**Comments of DPS Staff, City of New York, Multiple Intervenors and
Consumer Power Advocates on the Independent Consultant Study to
Establish New York ICAP Demand Curve Parameters for the 2021/2022
Through 2024/2025 Capability Years – Initial Draft Report**

July 2, 2020

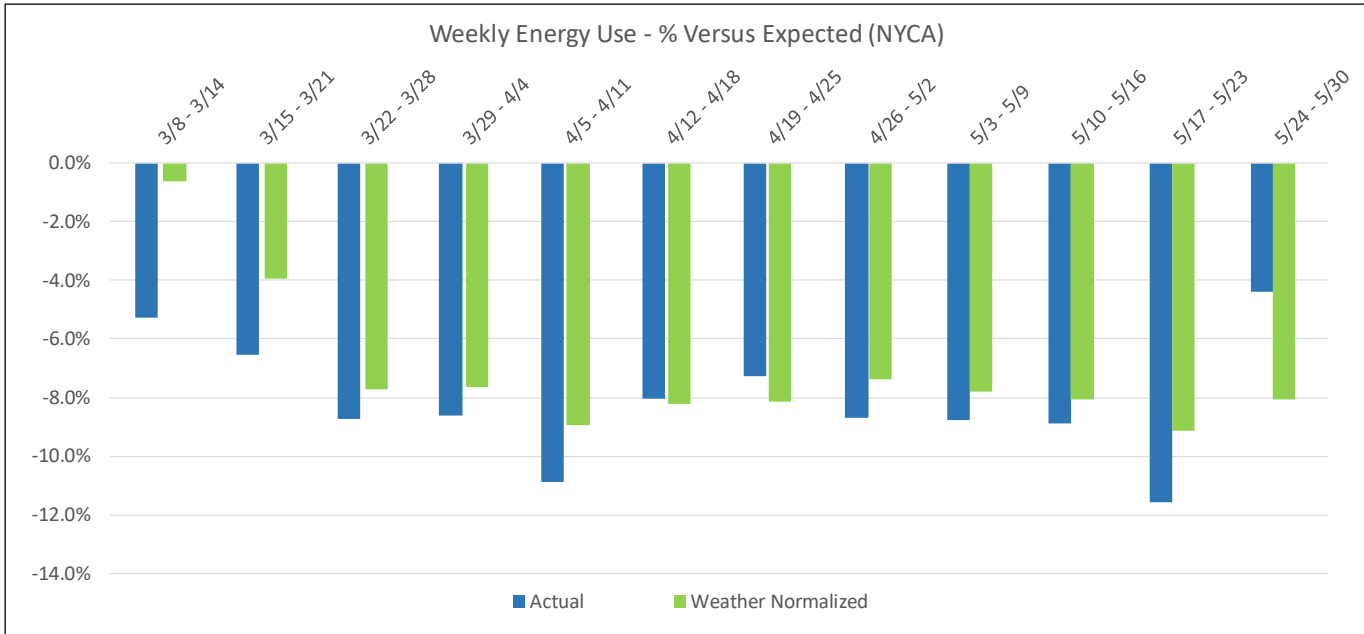
The Consultants used the same procedures for determining the level-of-excess adjustment

factors (“LOE-AFs”) that were used in the last DCR process and approved by FERC in its 2017 DCR Order. The Consumer Stakeholders submit that it is reasonable to use LOE-AFs in setting the ICAP demand curves, as they account for the impact that reducing the amount of excess capacity during the three-year historical period would have had on net EAS revenue. The Consumer Stakeholders also support the manner in which the Consultants’ calculated the proposed LOE-AFs in the Draft Report.

In FERC’s 2017 DCR Order, it found that the demand curves produced using the proposed LOE-AFs were consistent with the NYISO Services Tariff as well as just and reasonable.⁶ There has been no evidence presented, or change in circumstance, that would nullify FERC’s conclusions and/or warrant a departure from the current procedure for determining LOE-AFs. Accordingly, the Consumer Stakeholders support the Draft Report’s proposed LOE-AFs.

NYCA Weekly Energy Impacts versus Expected*

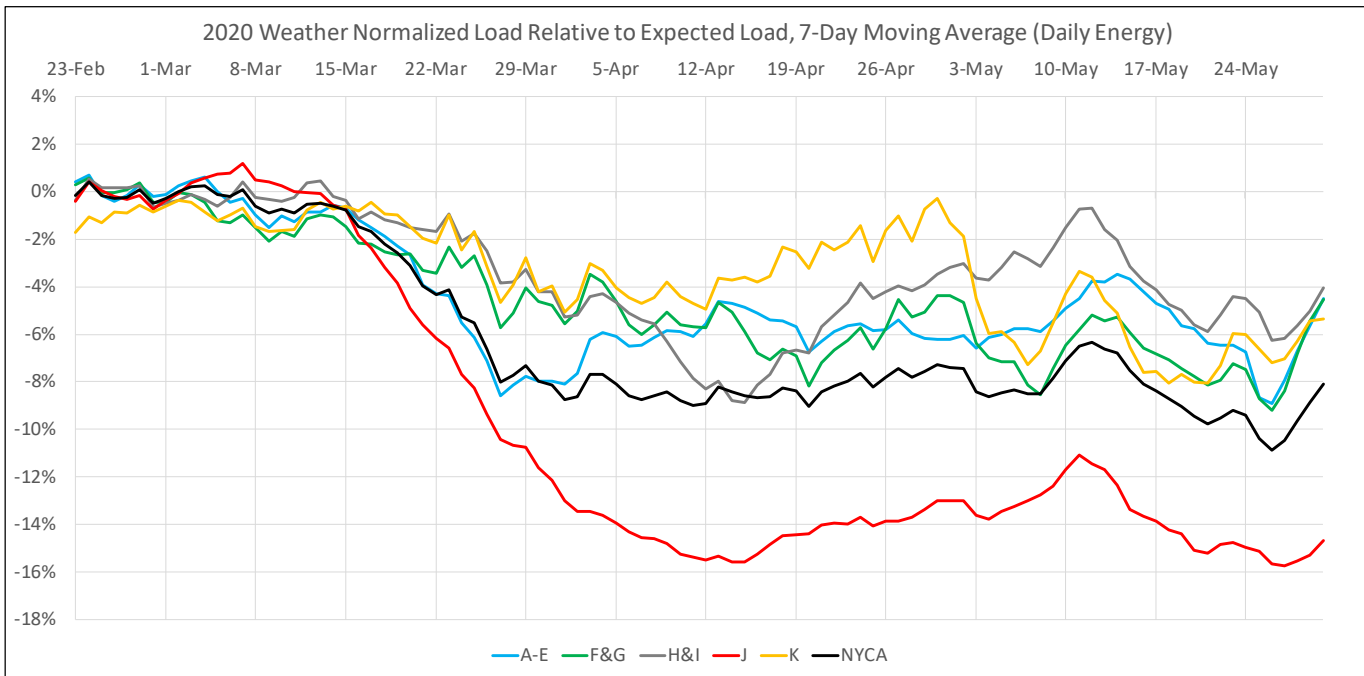
The COVID-19 pandemic has had an unprecedented impact on a number of industries and behaviors, including energy usage and energy prices. Due to the closing of many businesses and the temporary elimination or decrease of a material portion of energy demand, the most recent data is anomalous. Attached to these comments as Appendix A are charts from the most recent NYISO Monthly Report that demonstrate the impact on load that the global pandemic has had in New York

State. In some hours, the NYISO estimates that the actual load is nearly 14% lower than expected.

It is for these reasons that the Consumer Stakeholders strongly recommend that the Consultants adopt the preliminary forecasted revenues as final, and that the NYISO seek a one-time waiver from FERC to exclude the anomalous EAS revenues from the demand curves for Capability Year 2021/2022, the first year of the new 4-year DCR period. Under this period, during 2022/2023 Capability Year, the September 2016 to August 2017 period revenues would “roll off” and the September 2020 through August 2021 period revenues would “roll on.”

Regional Energy Impacts

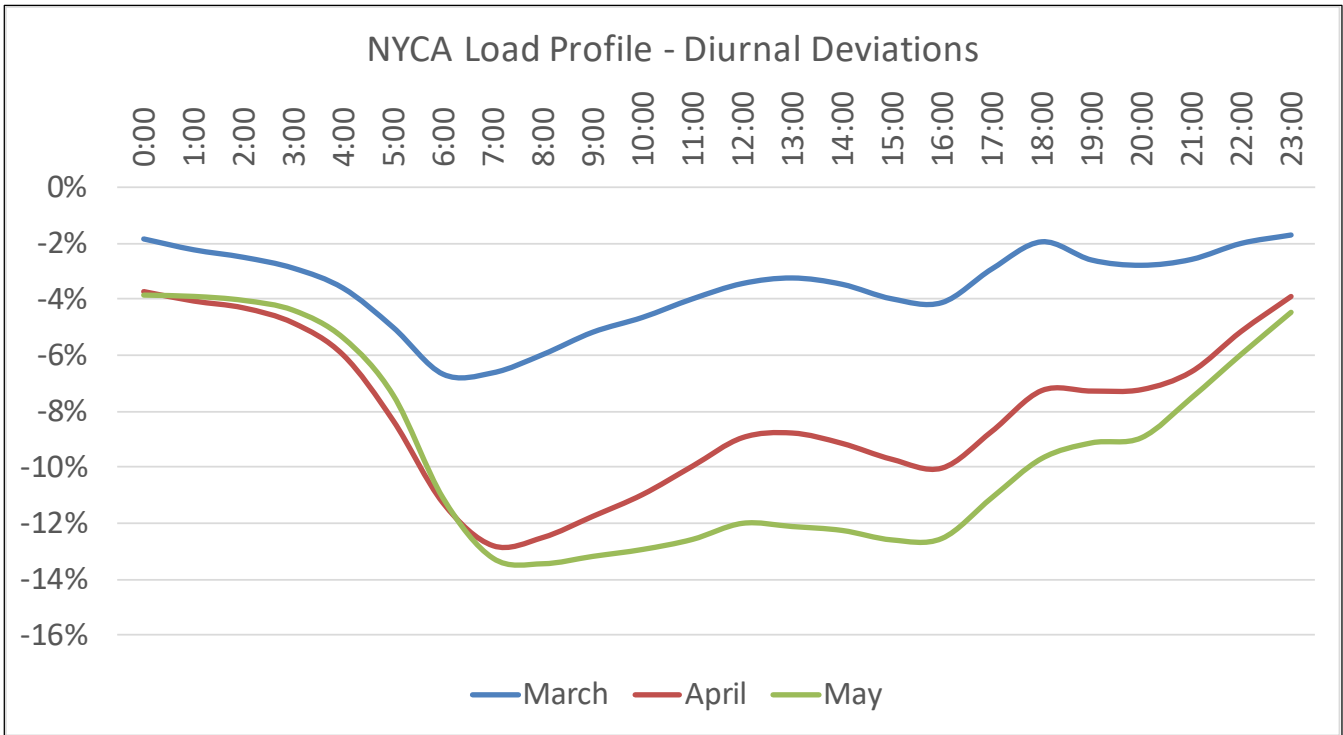
Importantly, the estimated impact of COVID-19 has only increased since March. The month of May 2020 had the largest impact yet on energy load and prices. Without question, energy prices this year have been anomalous to anything we have seen in the past. As projected revenues in the DCR process for the peaking unit are partly based on these prices, this fact will lead to forecasted revenues for the proxy unit that are much lower than would actually be expected over the life of the unit. Potentially even more troubling, if included, these anomalous prices would continue to remain in the calculations for the majority of the four-year demand curve period.
